RESPONSES TO  
NRC QUESTION  
ON THE  
DUANE ARNOLD ENERGY CENTER  
PUAR

PREPARED BY  
NUTECH ENGINEERS, INC.  
SAN JOSE, CALIFORNIA

PREPARED FOR  
IOWA ELECTRIC LIGHT AND POWER CO.

NRC QUESTION ON DUANE ARNOLD ENERGY CENTER

Figure 17 - 6"  $\phi$

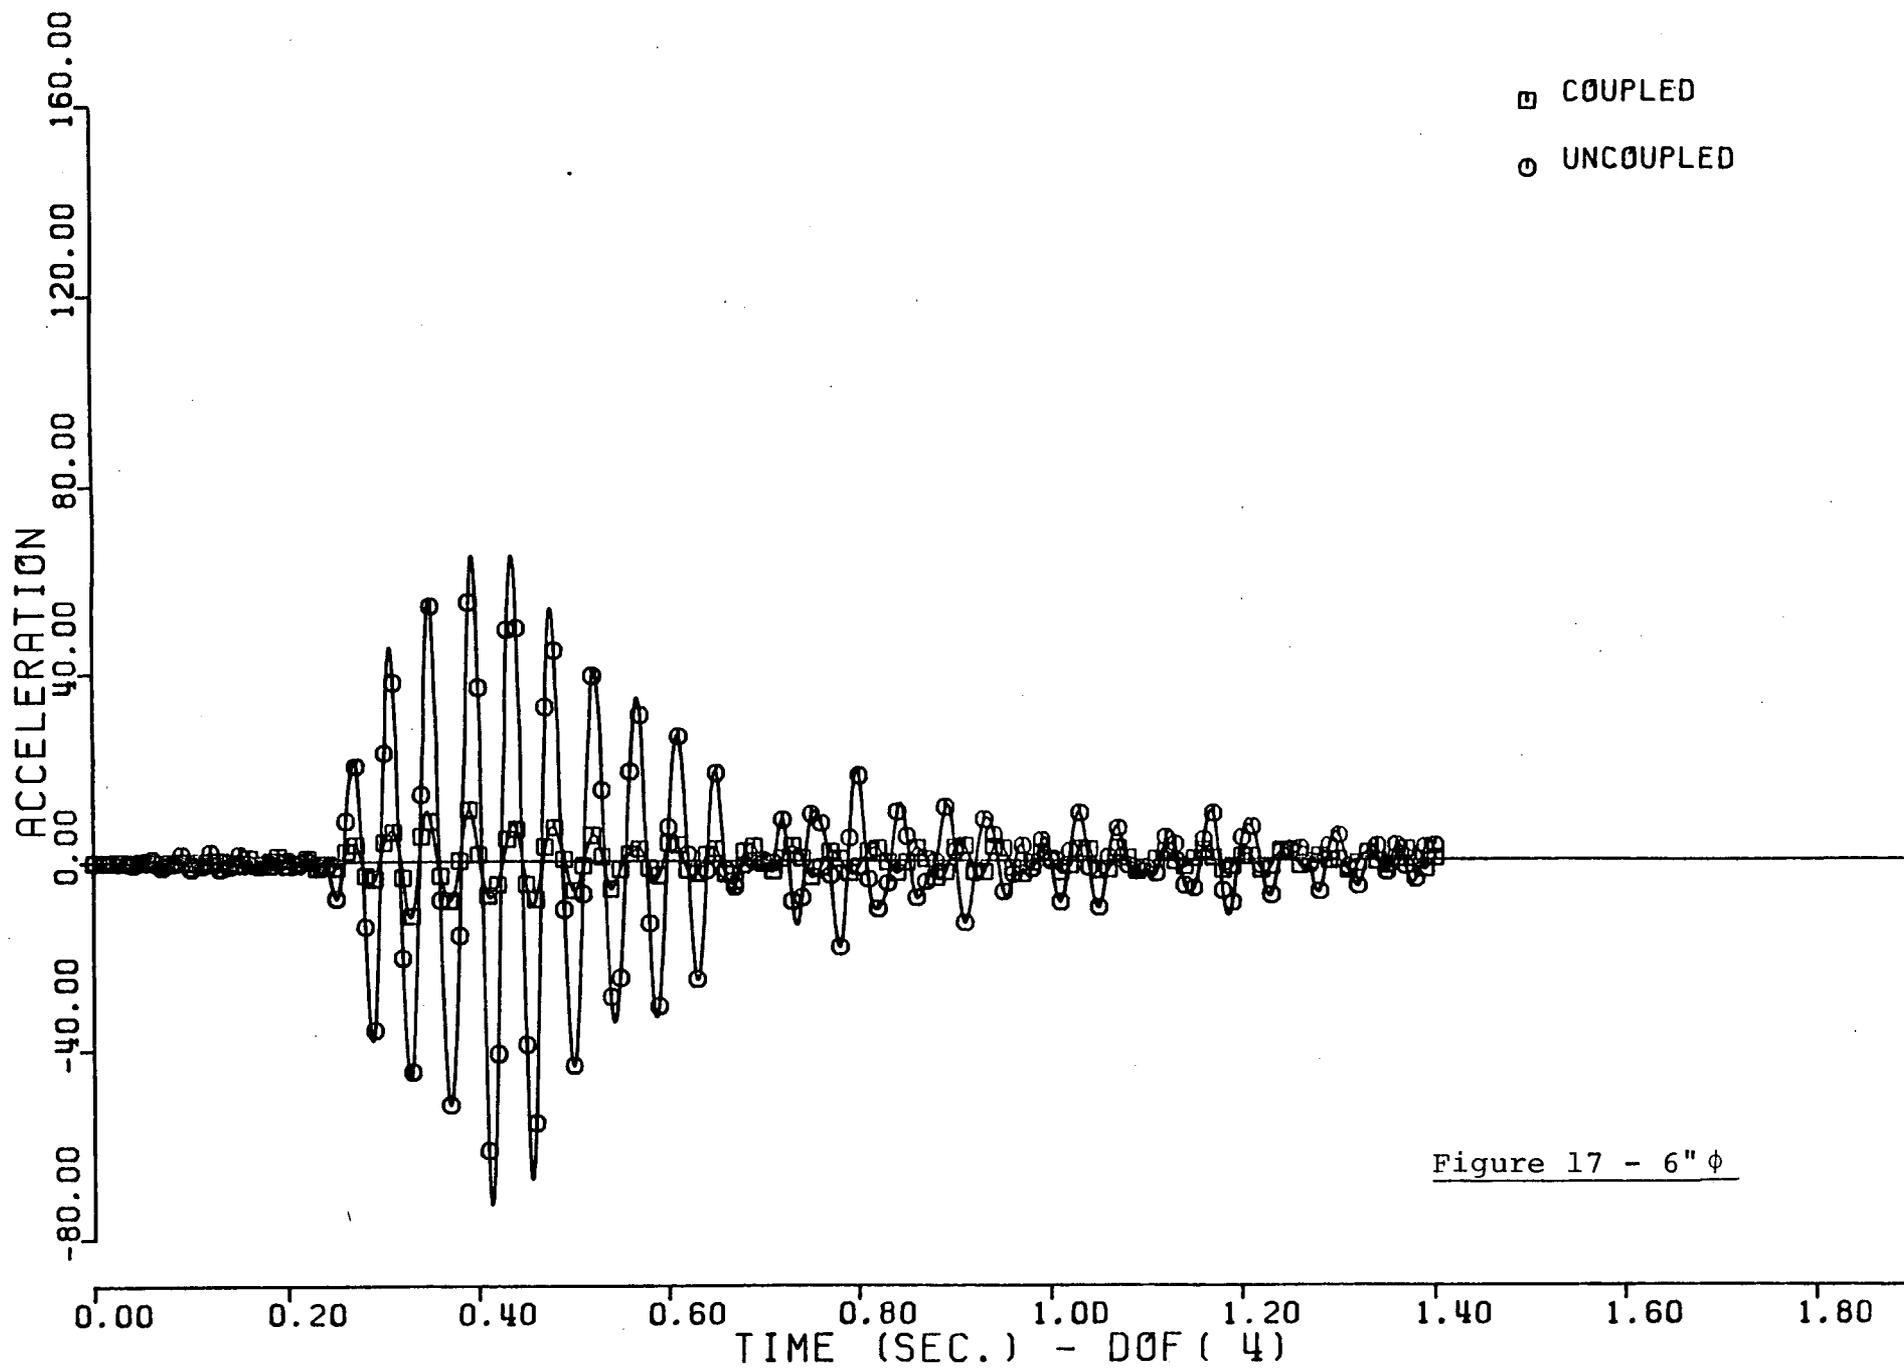
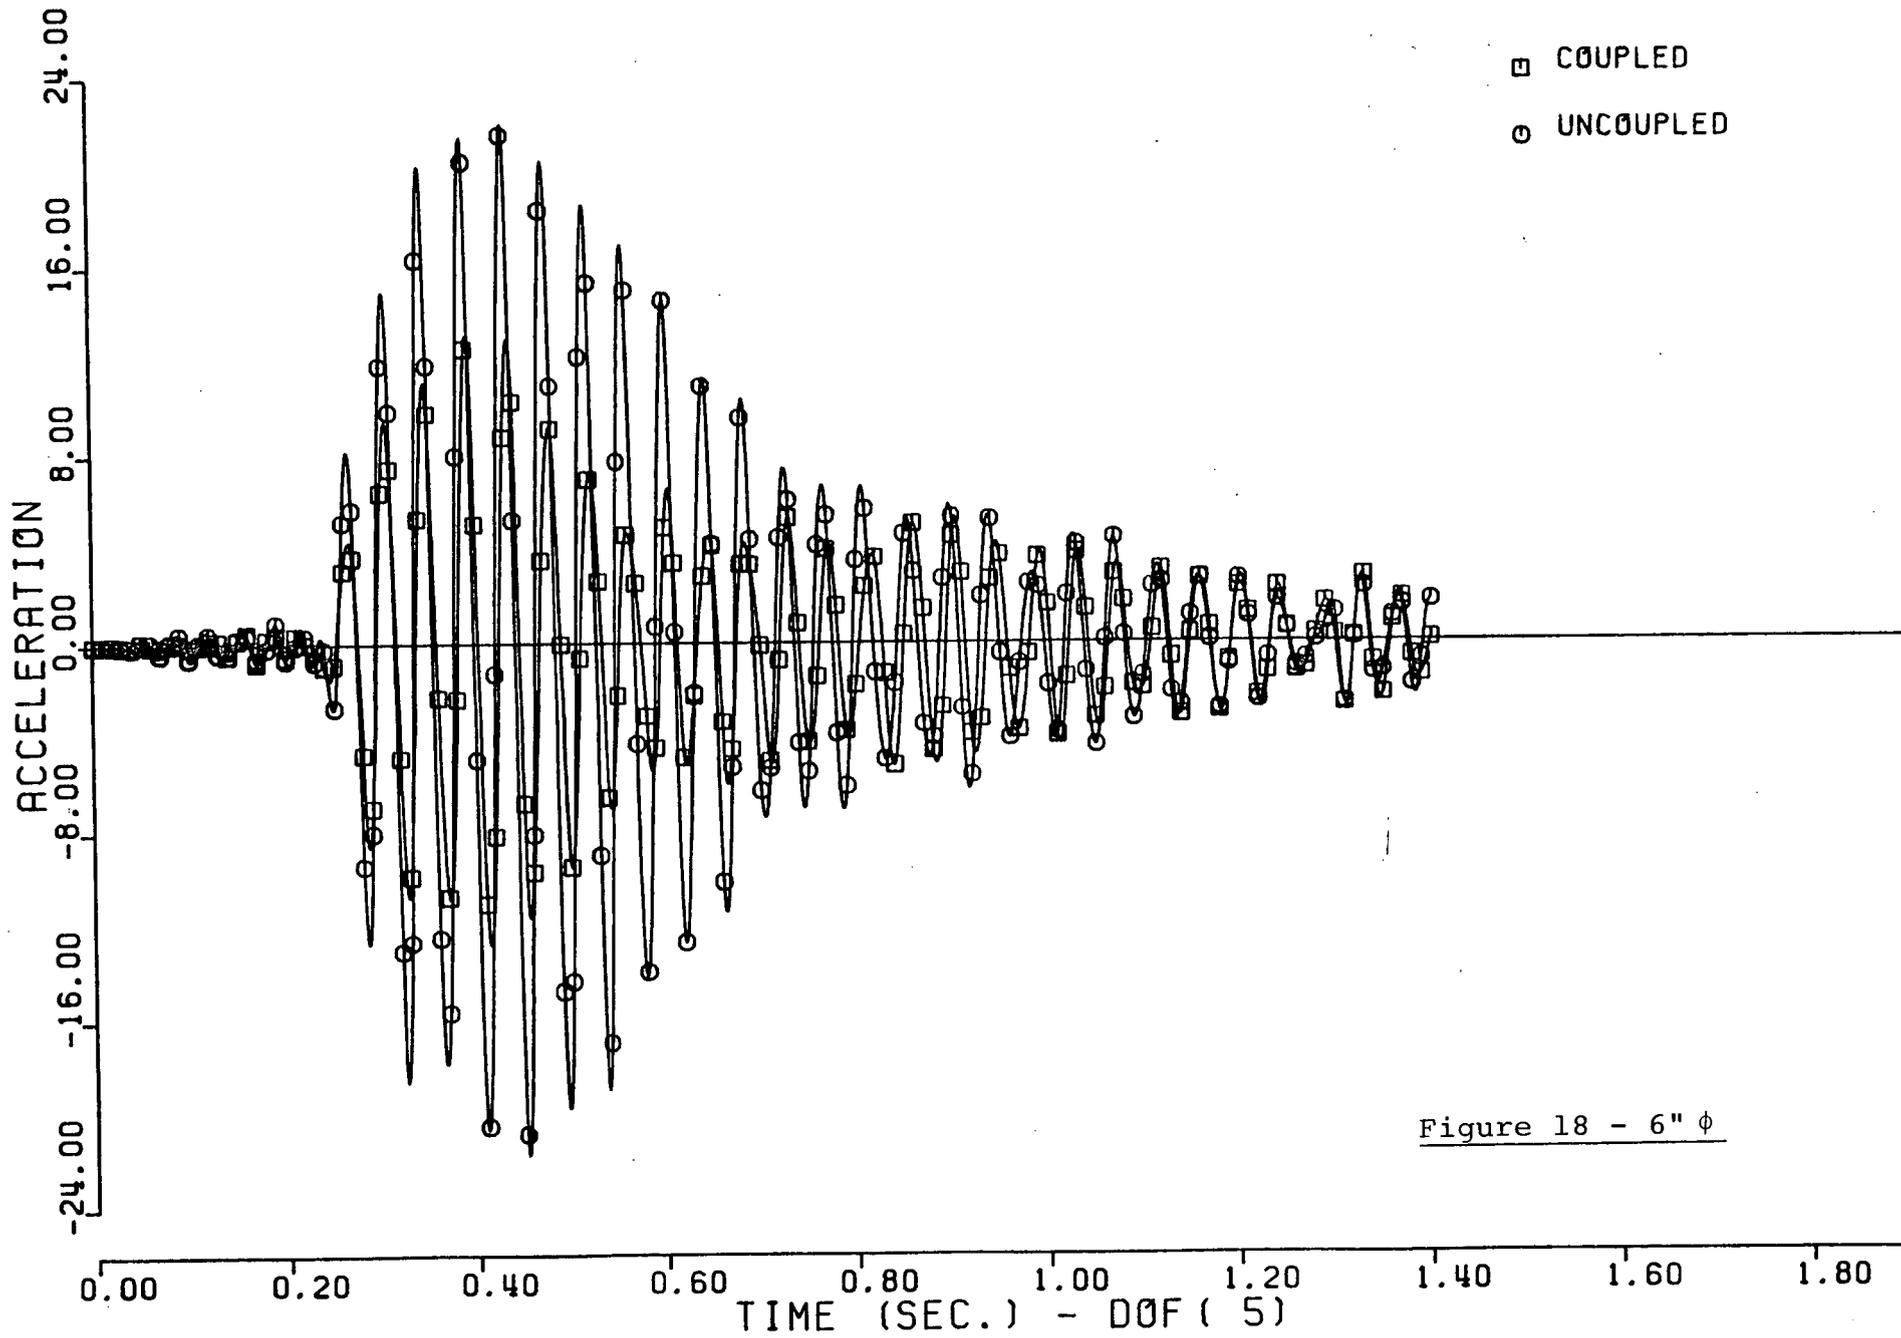
ITEM 3a: Provide the theoretical background in support of Section 2 of the report, and describe how the Section 6 guidelines (i.e., cut-off frequency and equations 2.27 and 2.28) have been used in the analysis.

To illustrate the effect of pipe size on coupling, four typical piping systems were examined and the coupled and uncoupled time histories plotted together. These time histories include both the smallest (2") and larger (20") systems analyzed. Listed below are the figure numbers and the corresponding line size.

Figure 4-8	2" diameter
9-13	4" diameter
14-18	6" diameter
19-21	20" diameter

These plots confirm the expected variation of coupling benefit with pipe size.
